U.S. Department
of Transportation
**Federal Highway
Administration**

In Reply Refer To:
HSSD/B-85E

Thank you for your letter of January 25, 2007, requesting the Federal Highway Administration's (FHWA) acceptance of your company's Modified King Block for use on National Highway System (NHS) with test level 3 (TL-3) Strong Post W-Beam Guardrail under the provisions of the National Cooperative Highway Research Program (NCHRP) Report 350 "Recommended Procedures for the Safety Performance Evaluation of Highway Features". The Modified King Block was accepted by the FHWA for use on the NHS with TL-3 Strong Post W-Guardrail in its acceptance letter HSA-10/B-85D of March 22, 2006, based on the results of pendulum testing. You now request the acceptance of essentially the same product with revised material composition based on full-scale crash testing. Accompanying your letter was a report on crash testing of your company's Modified King Block conducted by Southwest Research Institute and test videos.

TITLE: Guardrail Block
 DRAWN BY: S. KELLY
 DATE: 10/13/09
 DRAWING NO.: KING-FUTUREZ 1747 - 1
 SCALE: 1/4" = 1"

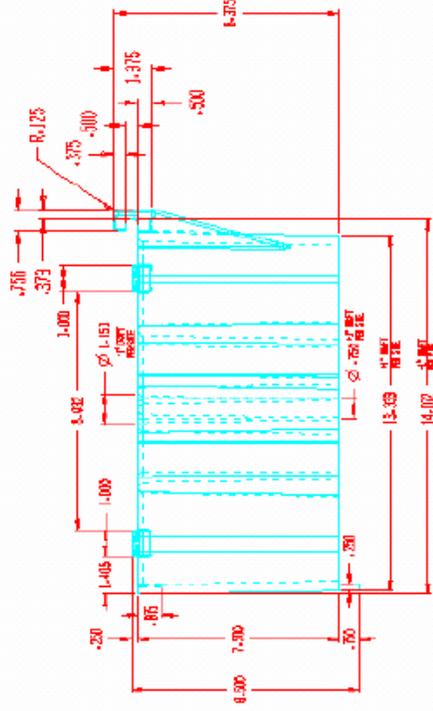
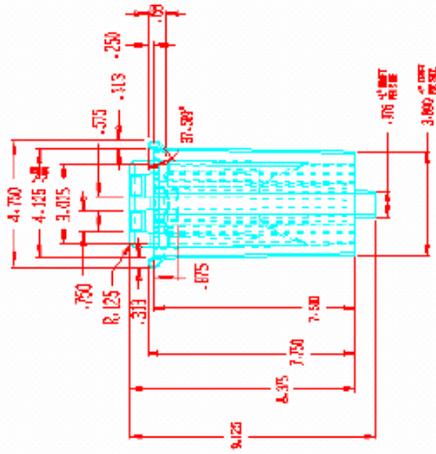
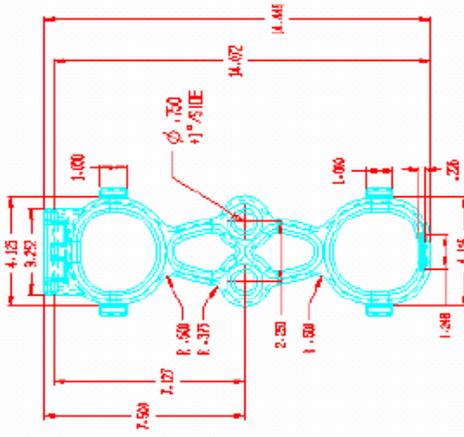
The Modified King Block consists essentially of an upper and a lower cylinder connected by additional structure that includes locations for bolt placement. A drawing of the Modified King Block is provided in Enclosure 1.

The Modified King Block used in full-crash testing underwent only one revision to the previously approved Modified King Block - material composition. Whereas the Modified King Block used in pendulum testing was composed of 68.5 percent recycled High Density Polyethylene (HDPE), 30 percent ground recycled rubber, 0.5 percent blowing agent and 1 percent color concentrate, the Modified King Block used in full-scale crash testing was composed of 70 percent recycled HDPE, 28.7 percent ground recycled rubber, 0.3 percent blowing agent and 1 percent color concentrate.

In summary, I agree that your company's Modified King Block, as described above, meets the appropriate evaluation criteria for a NCHRP 350 TL-3 device and may be used with TL-3 Strong Post W-Beam Guardrail at all appropriate locations on the NHS when selected by the contracting

authority, subject to the provisions of Title 23, Code of Federal Regulations, Section 635.411 as they pertain to proprietary products. This acceptance is limited to the use with the Strong Post W-Beam Guardrail on conventional W6 x 8.5 steel (or equal) posts. Further, I am assuming that production models will be identical to the prototype test units.
